Bullock Creek School District
2024 Bond- Series 2 - 2027 Renovations
HS / MS / Floyd and Pine River Elementary Schools

ADDENDUM #1

Project: No. 26-210 Bullock Creek 2023 Bond Series 2
2027 Improvements

Issue Date: November 2, 2026

SEAL	DRAWN TJA	PROJECT NO. 26-210
	CHECKED RGH	CAD FILE NO.
	REVIEWED RGH	DRAWING NO. B-E108
	DATE OCT 19, 2026	SHEET NO. 35 OF 38
	SCALE

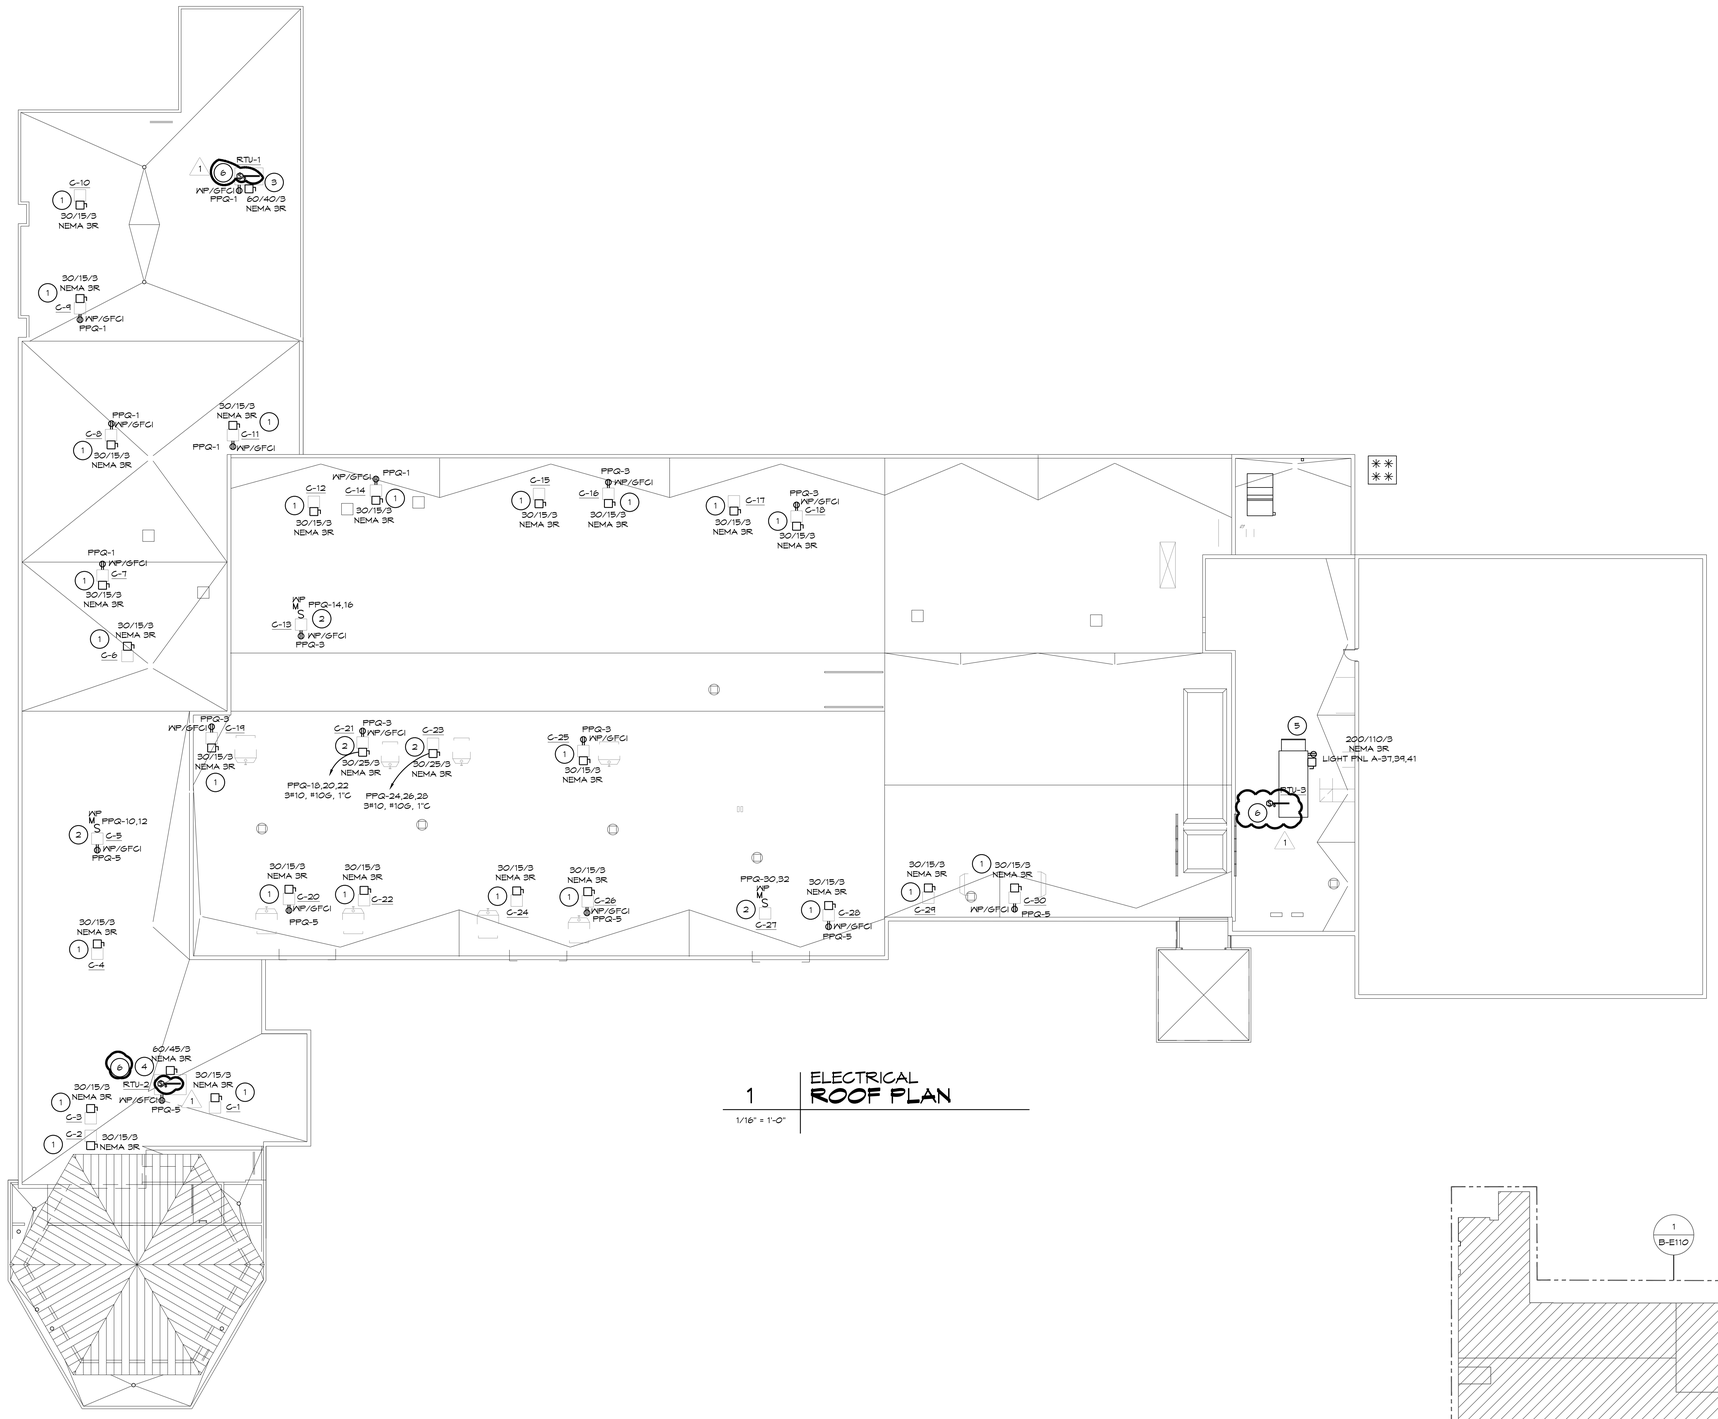
Item #E7: Revise Sheet B-E108 as follows:

a. Note for AHU revised for connection to duct smoke detector.
b. Fire alarm devices shown throughout renovated spaces, (Locker Rooms, Toilet Rooms, and new Shower/Toilet Room).

SEAL	DRAWN KRS	PROJECT NO. 26-210
	CHECKED JESS	CAD FILE NO. D-G001
	REVIEWED MLB	DRAWING NO. D-G001
	DATE OCT 14, 2026	SHEET NO. 1 OF 24
	SCALE N.T.S.

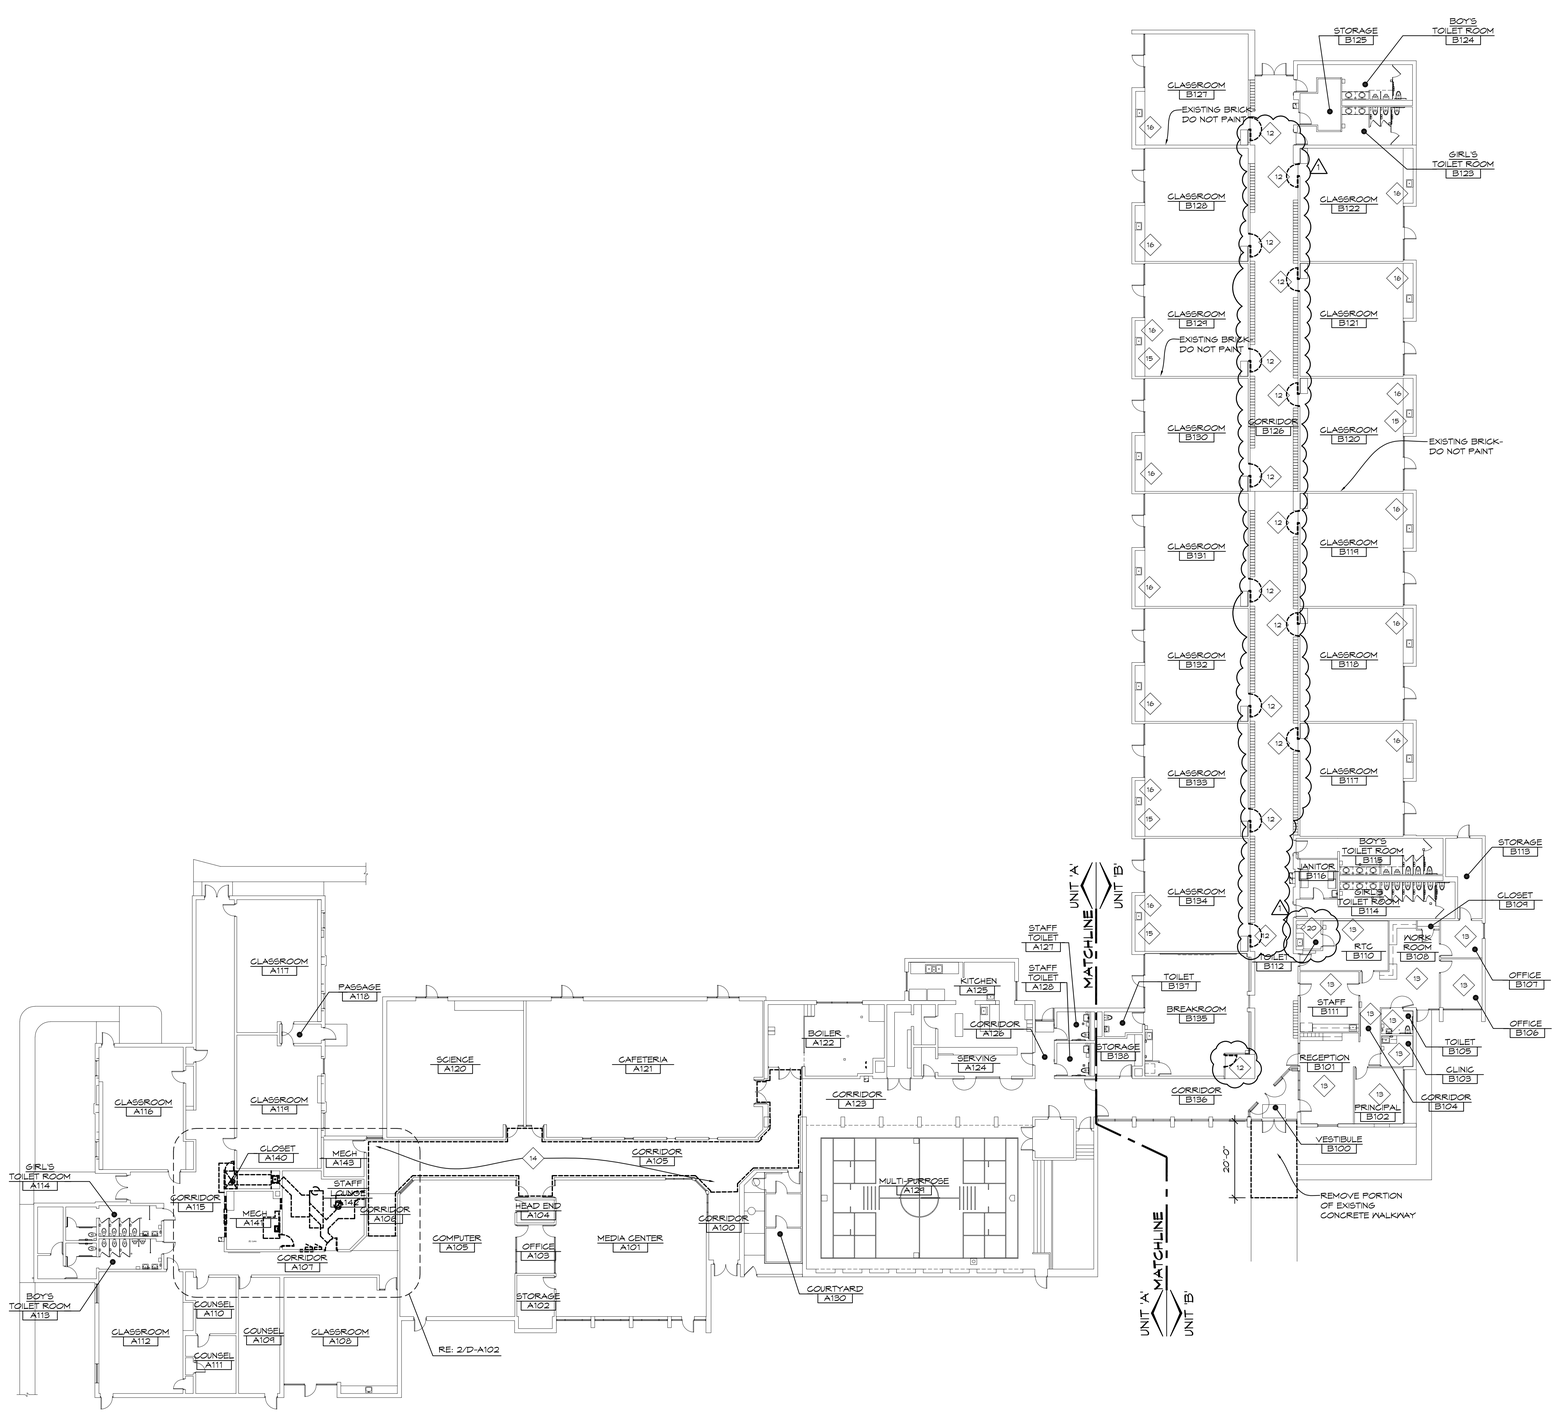
Item #A13: Revise Sheet D-G001 as follows:

a. Fire Separation Legend and Fire Separation Notes have been added.
b. Existing fire barriers have been added to Composite Plan.
c. Applicable Codes and Ordinances have been changed.

SEAL	DRAWN EVA	PROJECT NO. 26-210
	CHECKED JBS6	CAD FILE NO. D-A100
	REVIEWED MLB	DRAWING NO. D-A100
	DATE OCT 19, 2026	SHEET NO. 5 OF 24
	SCALE 1/16"-1'-0"

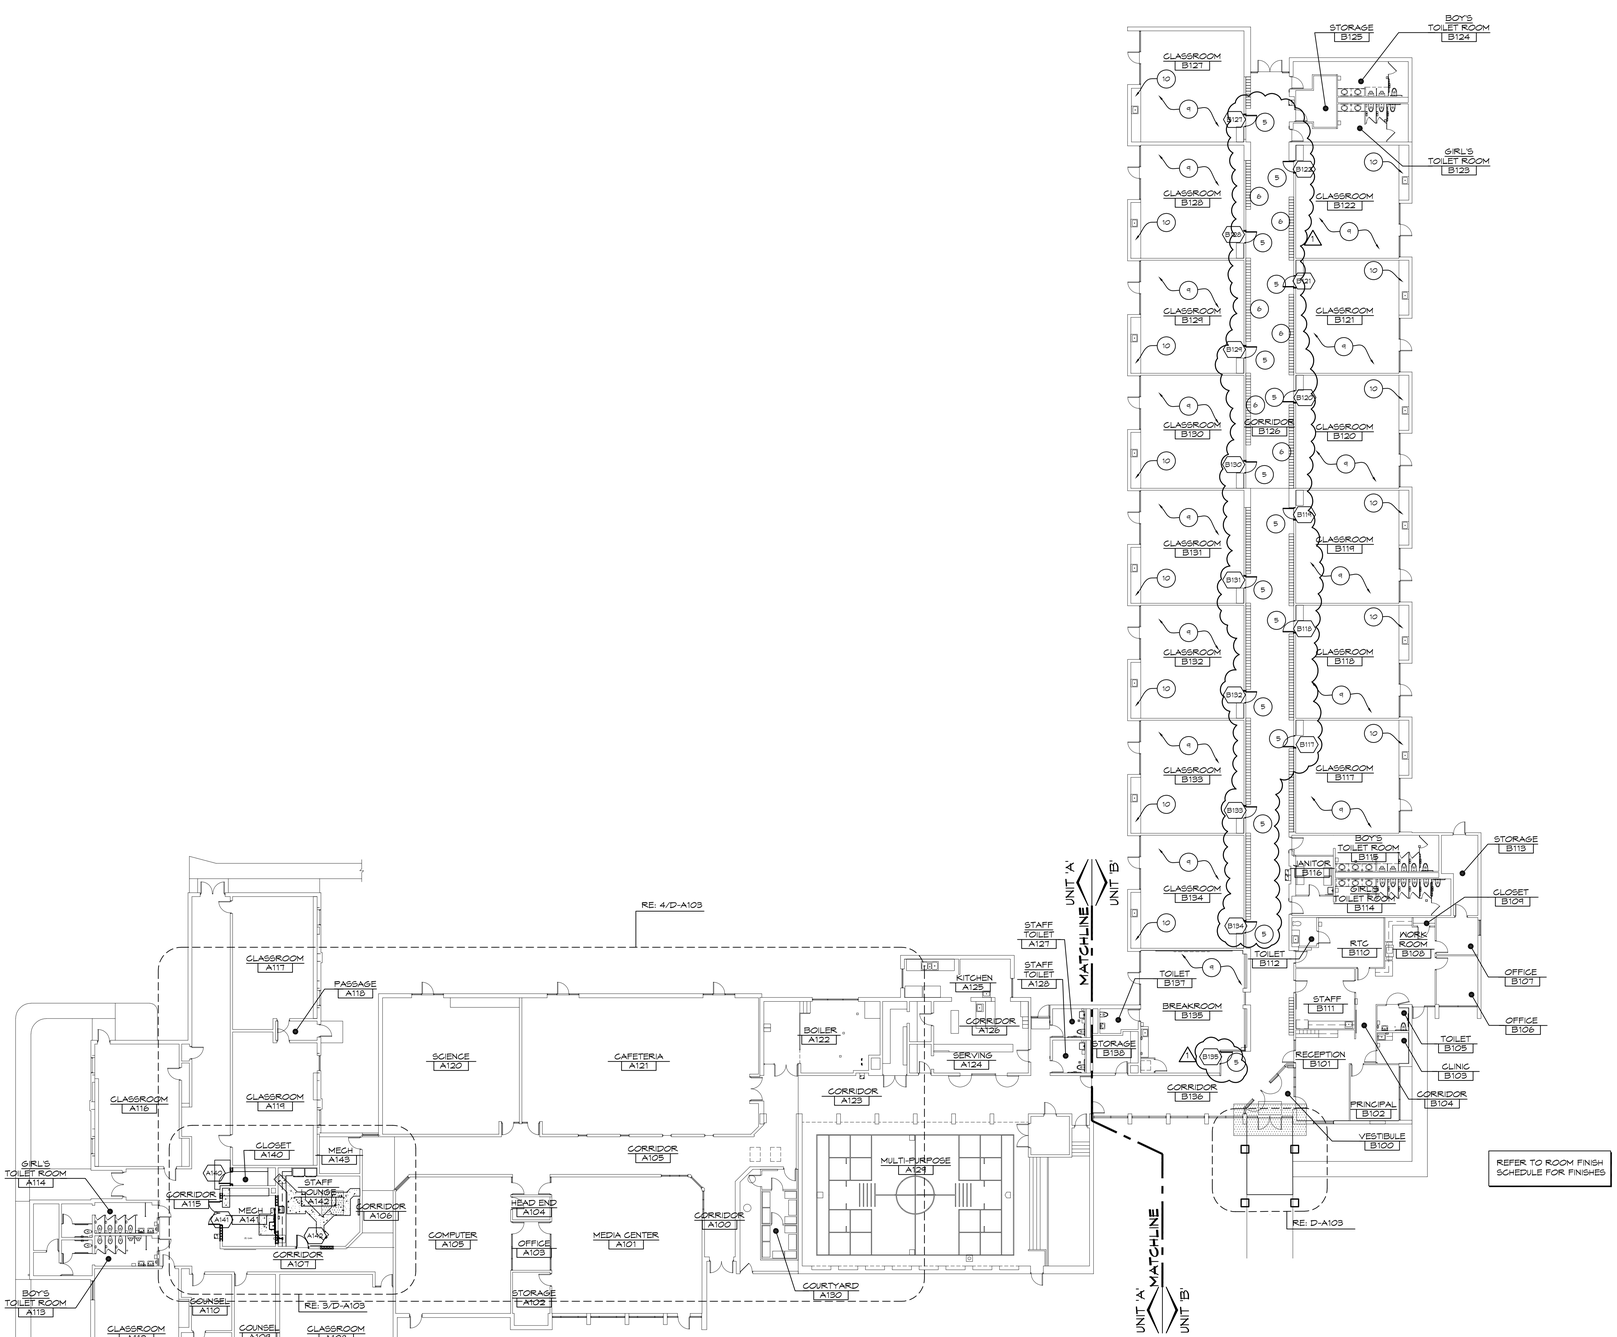
Item #A14: Revise Sheet D-A100 as follows:

a. Demolition Note 12 has been changed.
b. Demolition Note 13 has been changed to Note 20 at Room B112 on Composite Demolition Plan.
c. Demolition Note 14 has been changed.
d. Demolition Notes 20 and 21 have been added.
e. Wood Door Frames at Doors B117, B118, B119, B120, B121, B122, B127, B128, B129, B130, B131, B132, B133, B134, B135 shall be removed and new Hollow Metal Door Frames provided.

SEAL	DRAWN CJV/KLS	PROJECT NO. 26-210
	CHECKED KLS	CAD FILE NO. D-M101
	REVIEWED MLB	DRAWING NO. D-M101
	DATE OCT 14, 2026	SHEET NO. 14 OF 24
	SCALE AS NOTED

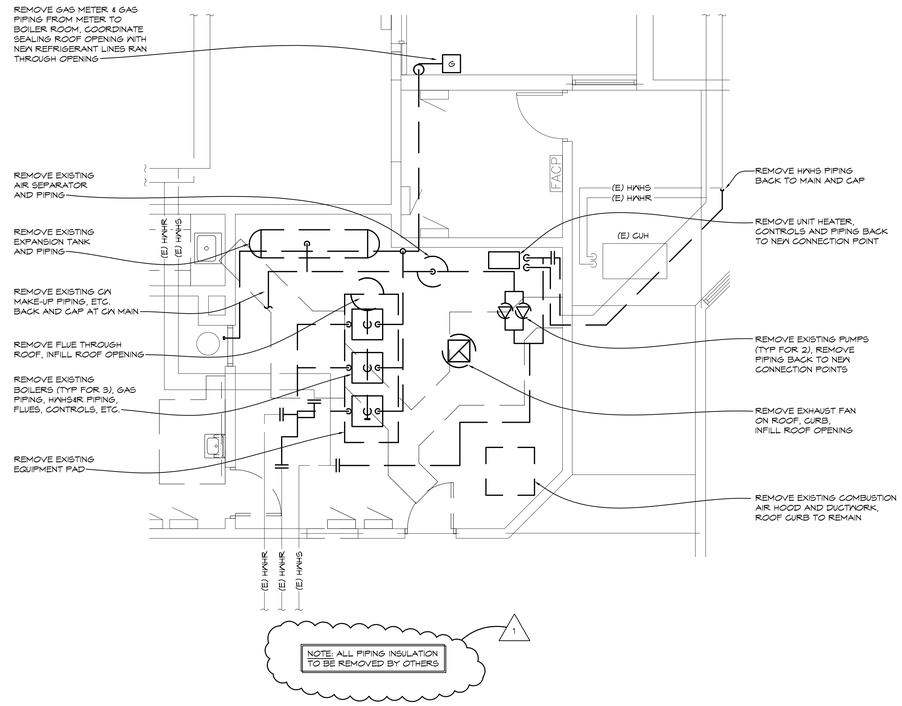
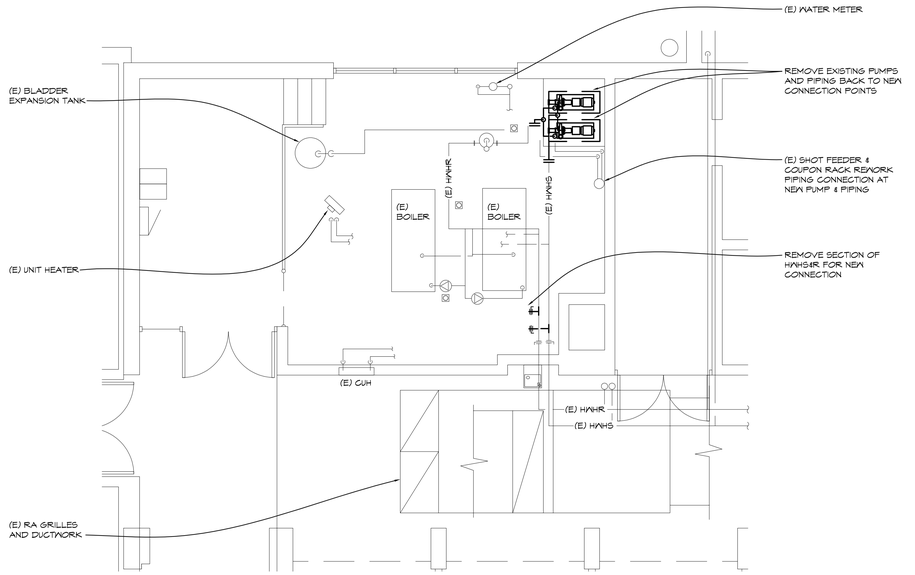
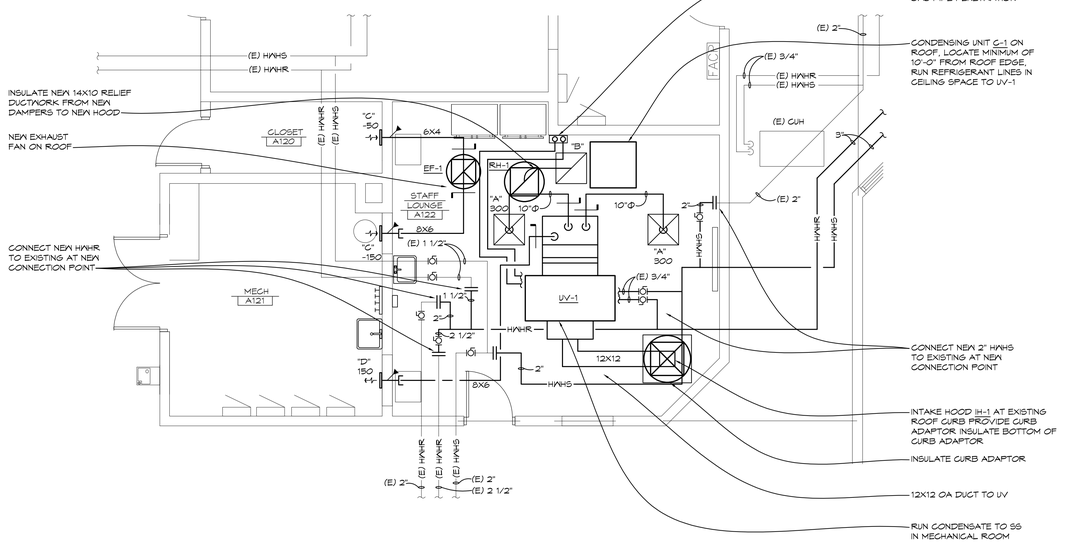
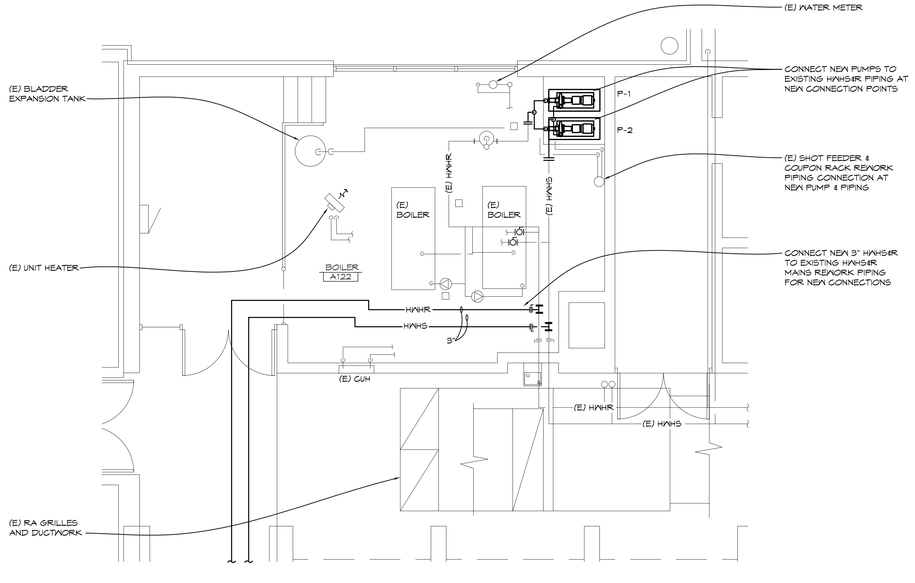
Item #M11: Revise Sheet D-M101 as follows:

a. Note "PIPING INSULATION TO BE REMOVED BY OTHERS AT NEW VALVE LOCATION" added at seven locations on Plan.

SEAL	DRAWN CJV/KLS	PROJECT NO. 26-210
	CHECKED KLS	CAD FILE NO. D-M103
	REVIEWED MLB	DRAWING NO. D-M103
	DATE OCT 19, 2026	SHEET NO. 16 OF 24
	SCALE AS NOTED

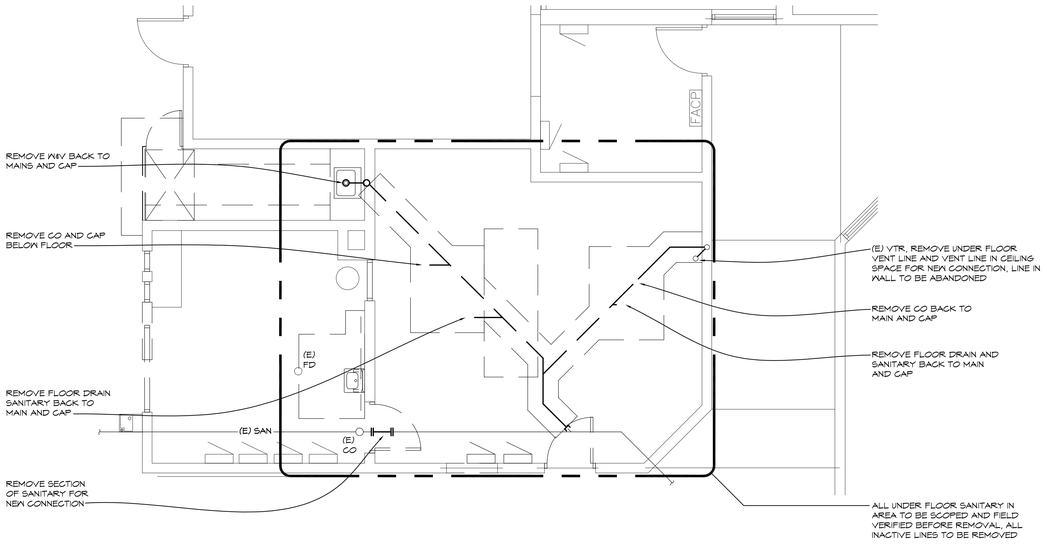
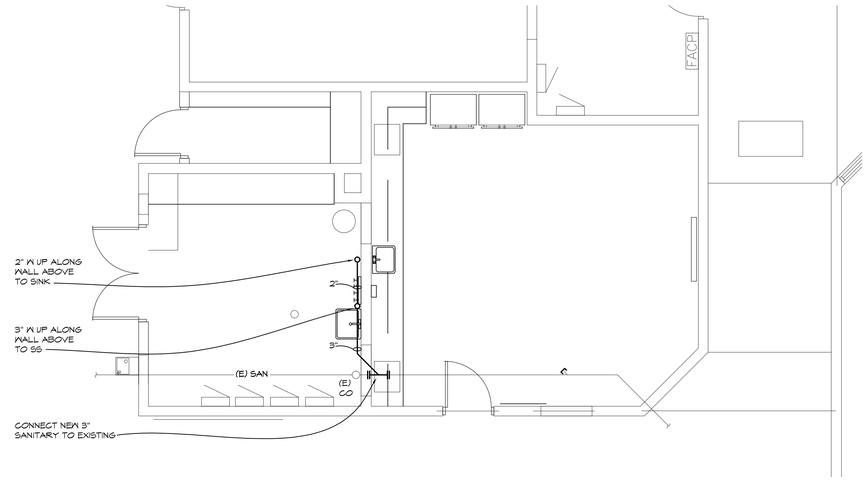
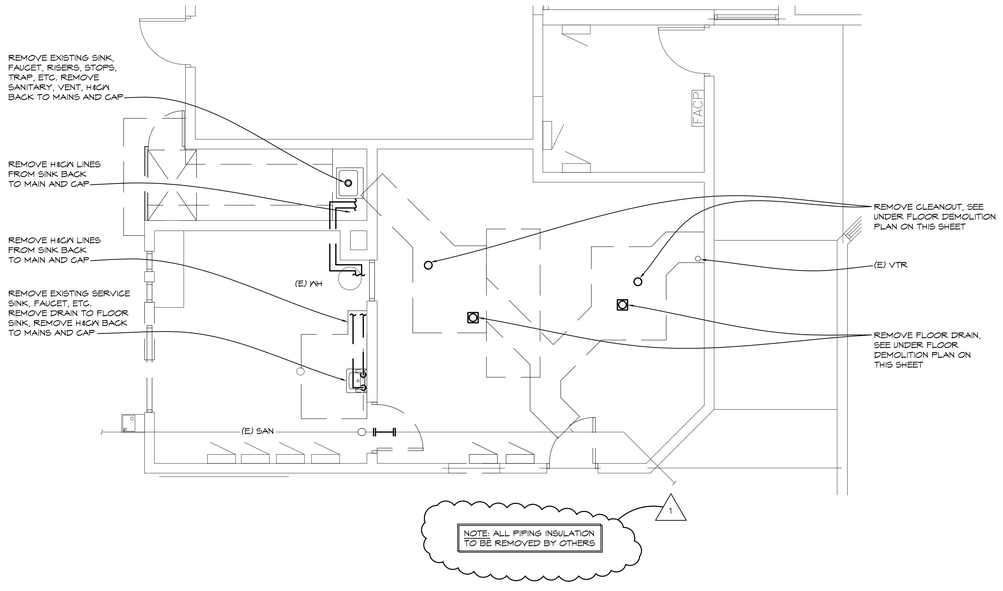
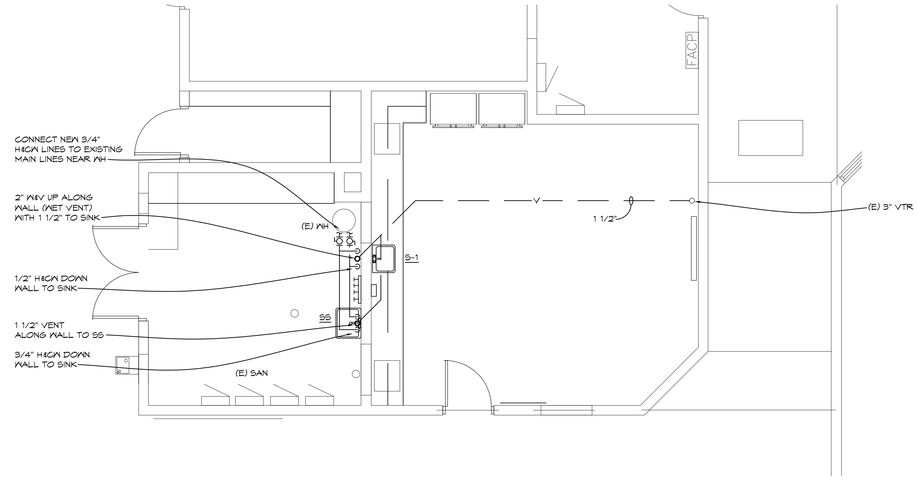
Item #M12: Revise Sheet D-M103 as follows:

a. General Note "ALL PIPING INSULATION TO BE REMOVED BY OTHERS" added to Demolition Plan.
